**U.S. ARMY CORPS OF ENGINEERS
NEW YORK DISTRICT**

June 2007

NY and NJ Harbor Deepening Project
**Appendix 6: Public Comment Letters and
Responses to the April Draft Environmental
Assessment**

Re: Comments on the April 4, 2007 Draft Environmental Assessment (“DEA”) of the Effects of the NY/NJ Harbor Deepening Project (“HDP”) on the Remedial Investigation/Feasibility Study (“RI/FS”) of the Newark Bay Study Area (“NBSA”)

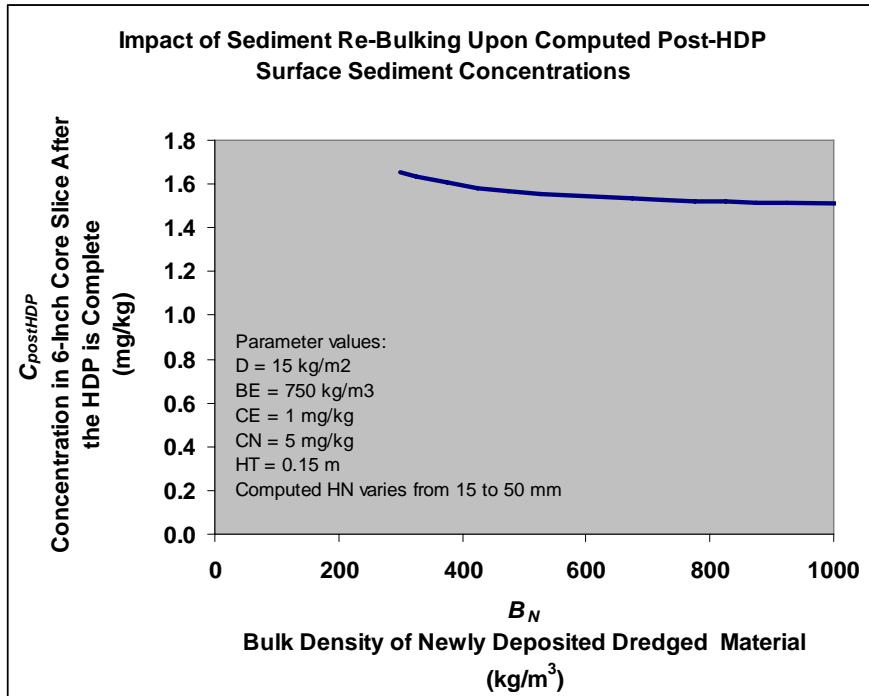
As noted above, larger masses of suspended sediment in a given area at a given point in time behave differently than smaller masses.

USACE RESPONSE: We do not concur. As for the mass effect on deposition rate and as noted earlier, a higher suspended sediment mass would only tend to enhance settling, not dispersion. Thus, the Corps' approach is conservative in this regard.

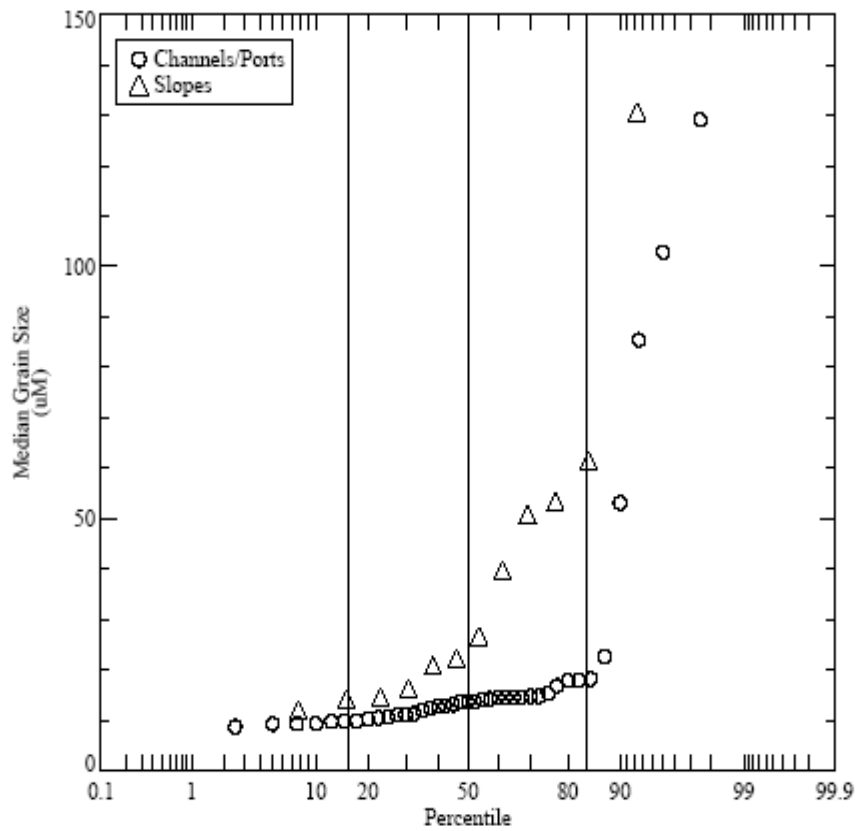
By averaging the contaminant levels in this way, the AEC analysis fails to account for the fact the sediment dredged from the side slopes – which is closer to the edge of the channels

– is more likely to contribute to deposition on the flats than sediment dredged from the channel bottom. In other words, the sediment depositing on the flats from a given HDP section will consist disproportionately of sediment from the side slopes.

USACE RESPONSE: We do not concur for the following reasons. The comment that “the fact the sediment dredged from the side slopes – which is closer to the edge of the channels – is more likely to contribute to deposition on the flats than sediment dredged from the channel bottom” is not accurate. The evidence is to the contrary; in fact the material from slopes is less likely to be widely dispersed than material from the channel bottom. The NBSA Phase 1 data show (please see figure insert below) that side slope material exhibits larger grain size than channel material. Larger grained material settles more rapidly and therefore disperses less. For this reason, the resuspension and transport of dredged material from the side slopes are likely to be less than the resuspension and transport of channel bottom material, which is comprised of smaller grain sediments.
